## Heritage Issues

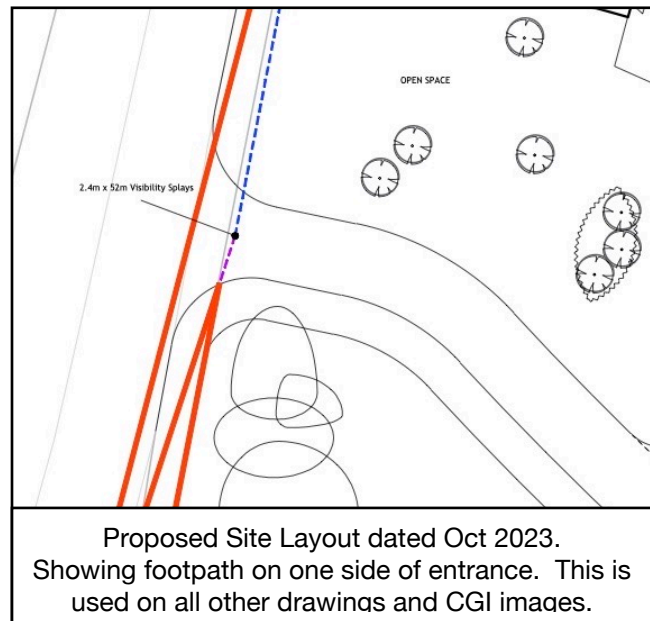
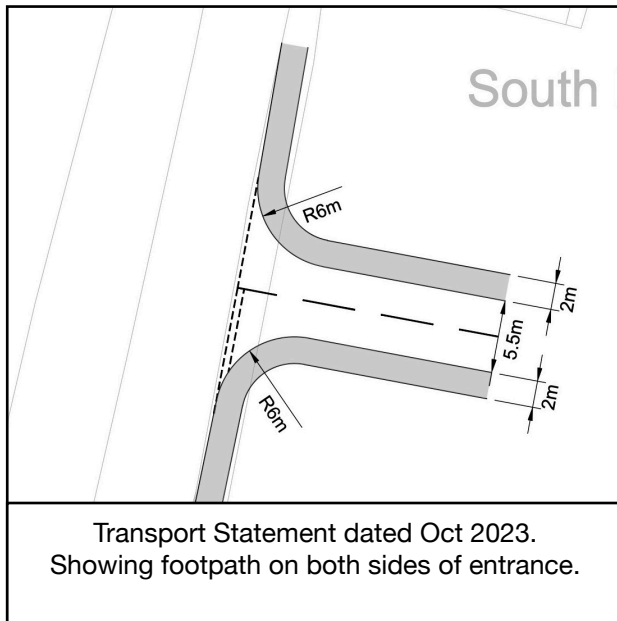
1. The WDC Conservation Officer stated that: “It would also be critical to retain the non-designated heritage asset that sits within the site and utilise the existing access onto the site rather than creating new access points”. There is no need for a new entrance to this site. One currently exists that is sufficient for 20 homes and this should be utilised. It would simplify the South Street access and improve safety. The proposed new entrance is shown in 2 conflicting forms:

The picture above shows the applicant's CGI of what they want to present to the planning committee as the site entrance.

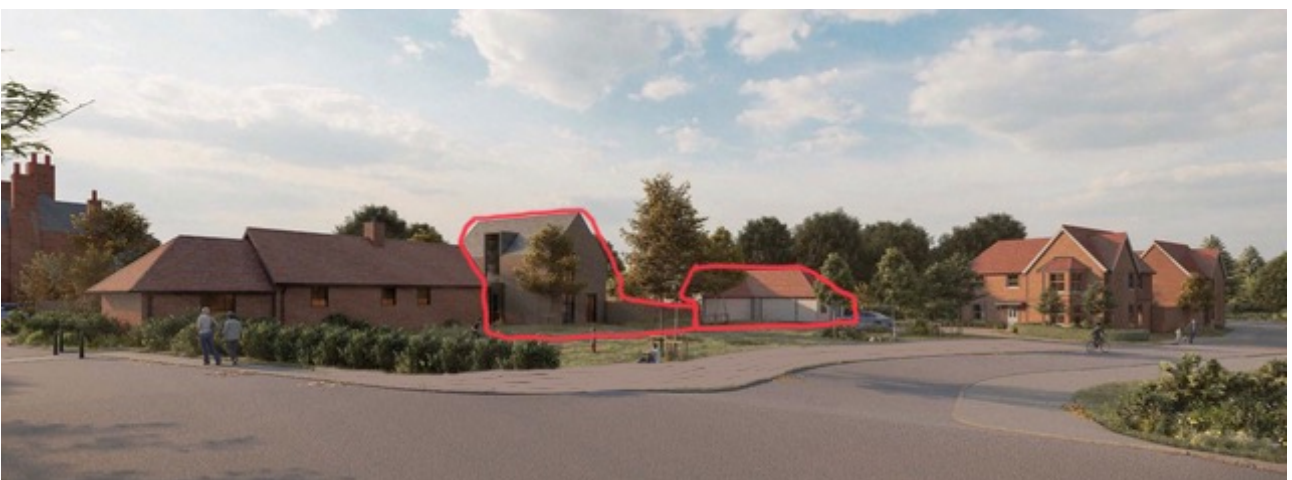
This is a more realistic version of the same site entrance with the additional pavement added and some vehicle parking which would no doubt occur as a result of an inadequate parking space allocation for the 20 homes.

3. In both the images above, this does not represent a preservation of the rural edge of the village and the Conservation Area. The only way to comply with this would be to reduce the two storey extension to the stable block and the garage block so that the Circle of Oaks can be seen. Also, the creation of an unnecessary road access and pavements ruins the rural aspect of this image. The inclusion of this unnecessary access will cause harm to the Setting of the Conservation Area and Non-Designated Heritage Assets.

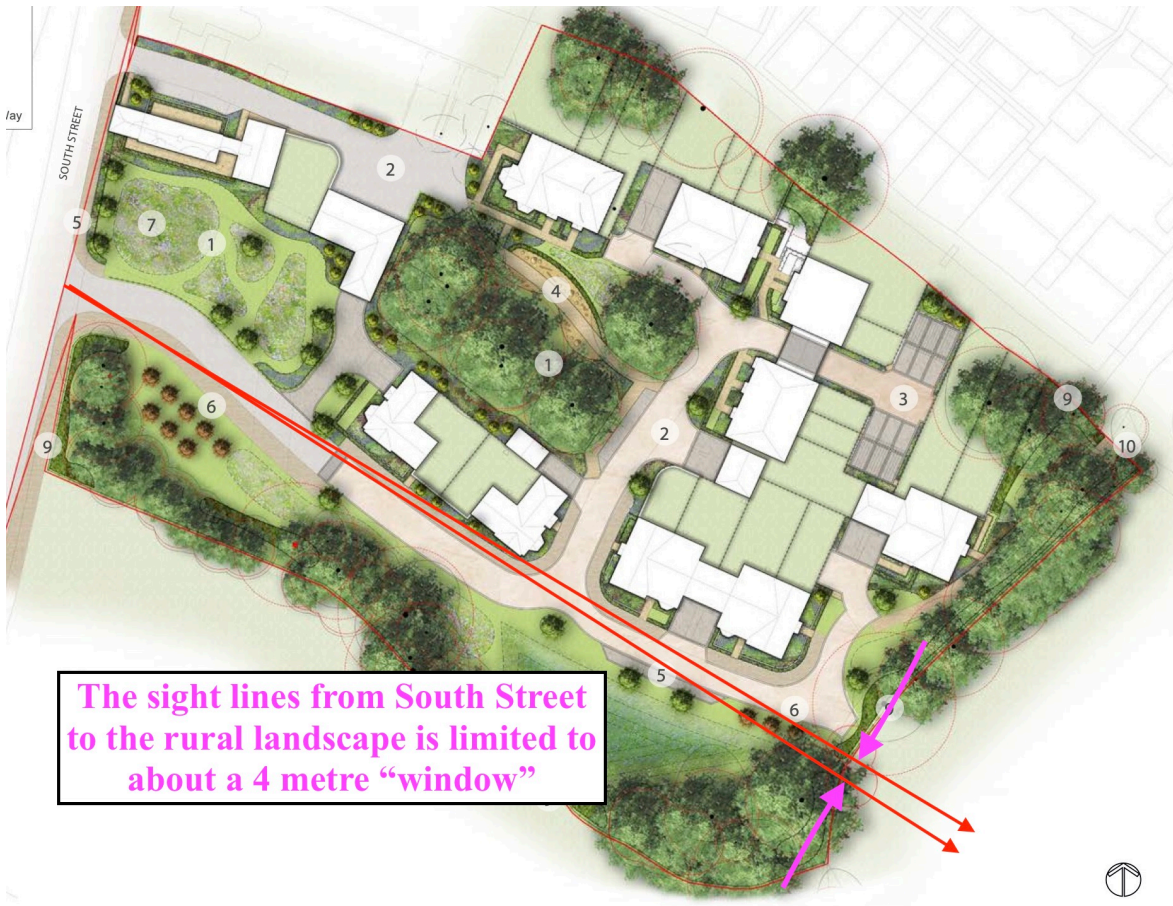
4. Plot 3 is not a good solution to the conservation issue and will not address the harm to the Setting of the Conservation Area and Non-Designated Heritage Assets. The Conservation Officer suggested: “the stables building should also be provided with a use to ensure its long term repair and maintenance and it was suggested that this could be converted to a single storey dwelling, perhaps with a small extension”. The applicants proposal is not for a small extension. It is a 3 bed home of two storeys which increases the floor area of the original single storey dwelling by 161%. A small extension might be to accommodate a one bedroom house with a one storey extension. Using the stables as a commercial space would also be a possibility and bring some employment opportunities to the community or possibly a community building.

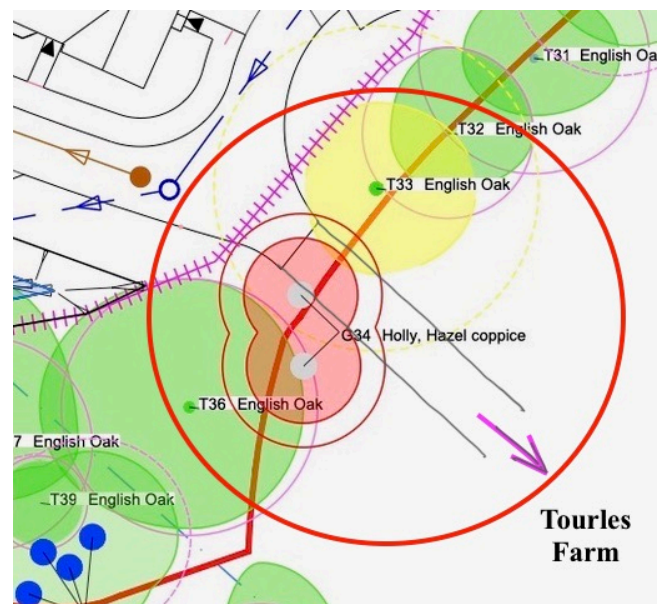
(2) They have prematurely installed a gate onto South Street to suggest that this access to the site has always existed. In doing so, they replaced a traditional post and rail fence (still referred to in the Applicant's Design and Access Statement, page 20) with post and wire fencing contrary to the WDC guidance contained in the Applicant's Landscape and Visual Impact Assessment, page 13.

(3) They have felled a significant Oak Tree [T33 'A' category (high value)] and propose the removal of G34 (a group of Holly/Hazel) on the eastern boundary of the site and propose to build a small section of road leading to their proposed access way into the fields beyond. It is not clear if permission was sought to fell this significant Oak Tree.

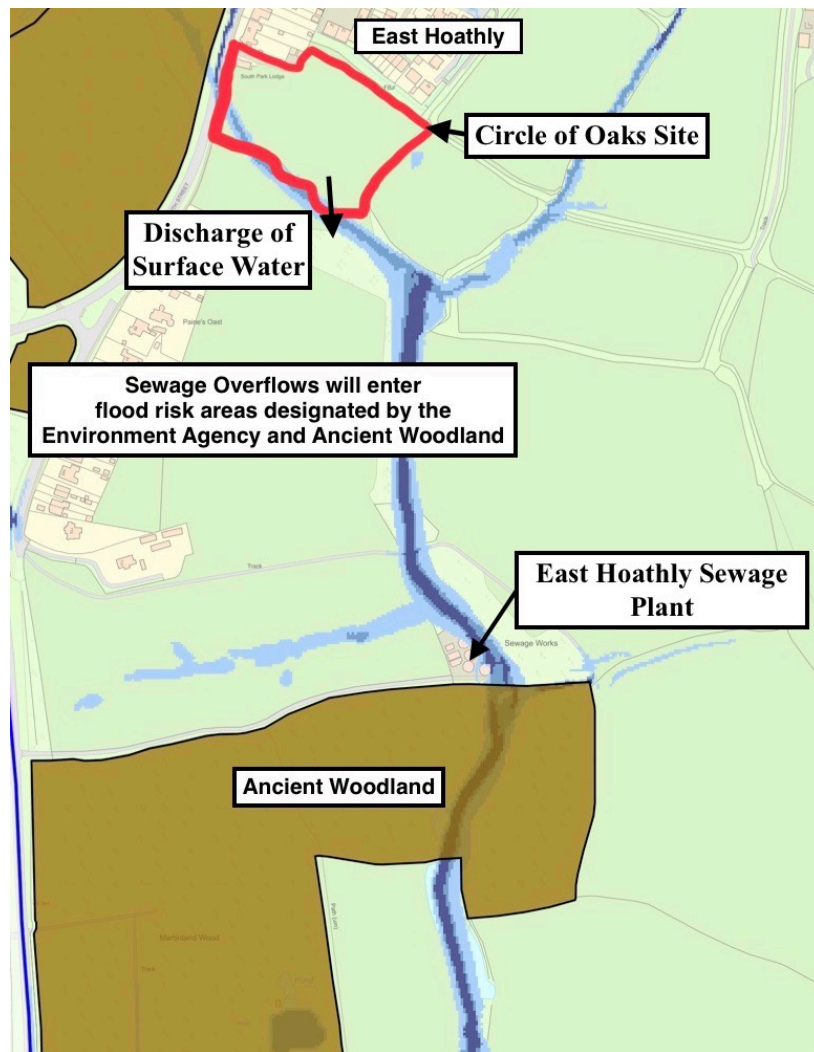
(1) The proximity of 2 housing developments with 3 vehicle access points onto South Street within 90 metres of each other is going to be hazardous and ESCC should give this a full analysis.

(3) The proposed development will collect all storm water from roofs and gutters and all surface water drainage into underground tanks which feed into an attenuation pond in the South East corner of the site. This will then discharge through a pipe onto the land that has been approved for development of 55 houses. This focussing of all the rain water into one discharge point will have an effect on the flood risk in the area of discharge and beyond. This has not been considered in the Flood Impact Assessment and there is no indication that the Applicant has liaised with the adjoining landowner. This has also not been considered in the Ecological Appraisal. This area is already known to be an area at risk of flooding:

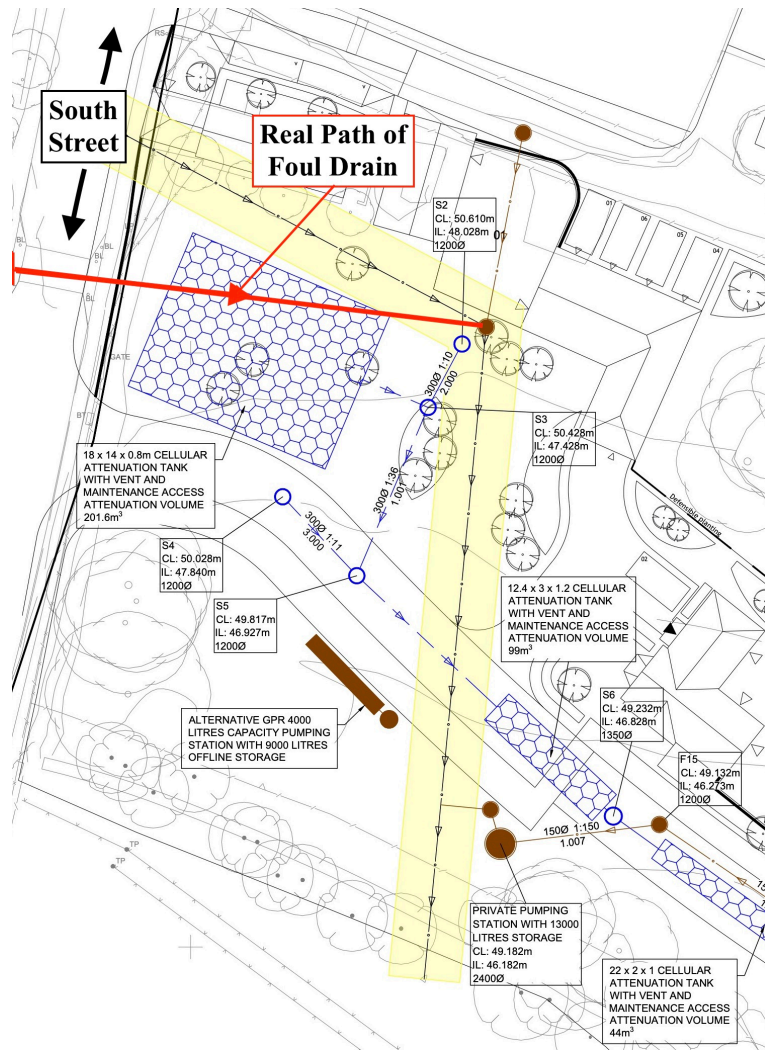
(4) The foul drainage plan is confused and not sufficient for a full planning application. Southern Water (Southern Water Reference DSA000022709 dated 19 May 2023) has apparently indicated that there is no capacity issue but there is no indication that this letter has taken into account the development on South Street or Hesmonds. The foul drain position on the site plans are incorrect when compared to the Southern Water plans. This would have an impact on the proposed underground storage tank shown on the drainage plan. On another document (WD-2023-2516-MAJ\_Statements-Reports\_TF1237-FAB-00-XX-RP-G-830, Appendix 3) the foul drain is shown in another position entirely and marked as “existing sewer diverted”. The proposed route takes the sewer underneath the attenuation pond. These plans are a mess and inadequate for a full planning application. There is no indication if the Applicant has liaised with the adjoining landowner regarding this proposed re-positioning of the sewer nor any liaison with Southern Water, nor the PC.

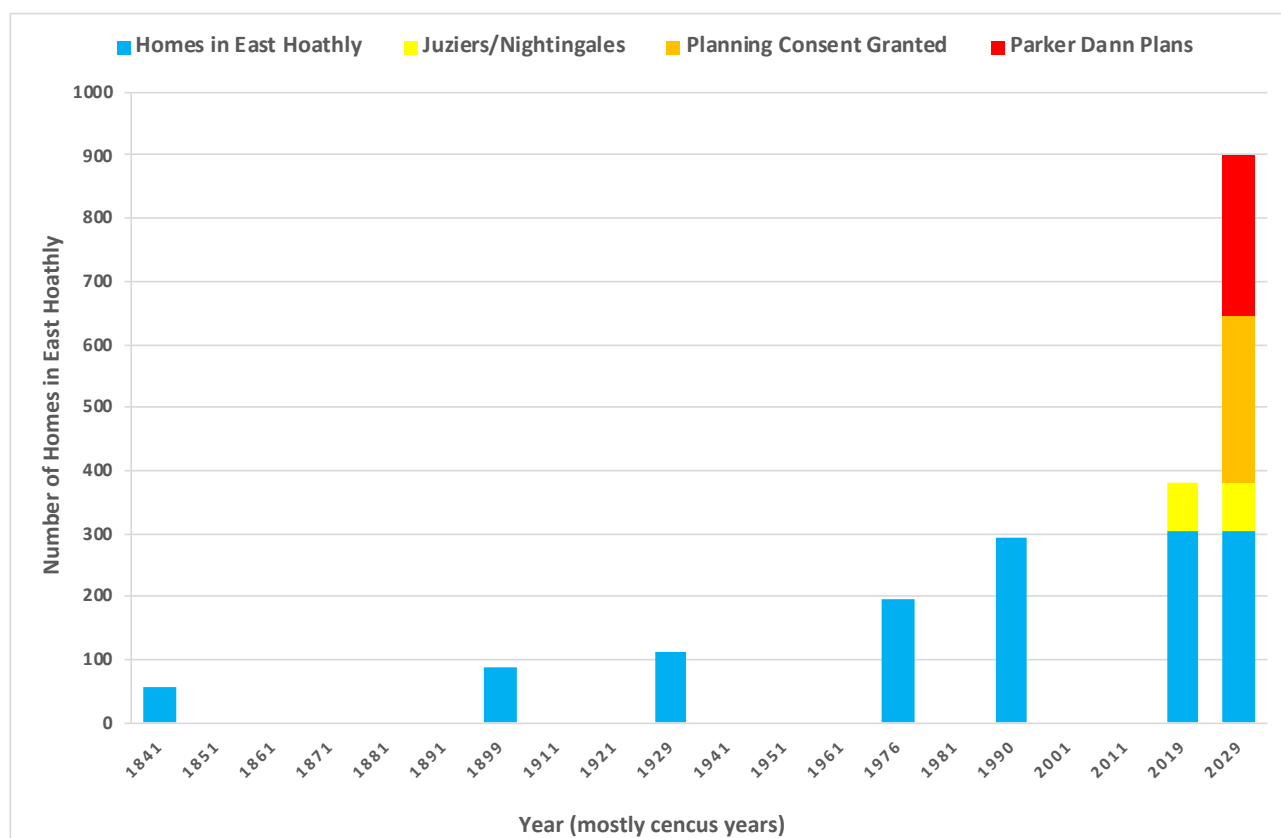
10. When the approved 55 homes are built on South Street, the Green Gap at the Circle of Oaks will be the only remaining corridor linking the wildlife of

the Ancient Woodland to the West (in Moat Wood) to the open countryside to the East and South of the Village. If the land is developed it would close this corridor and isolate this wildlife.
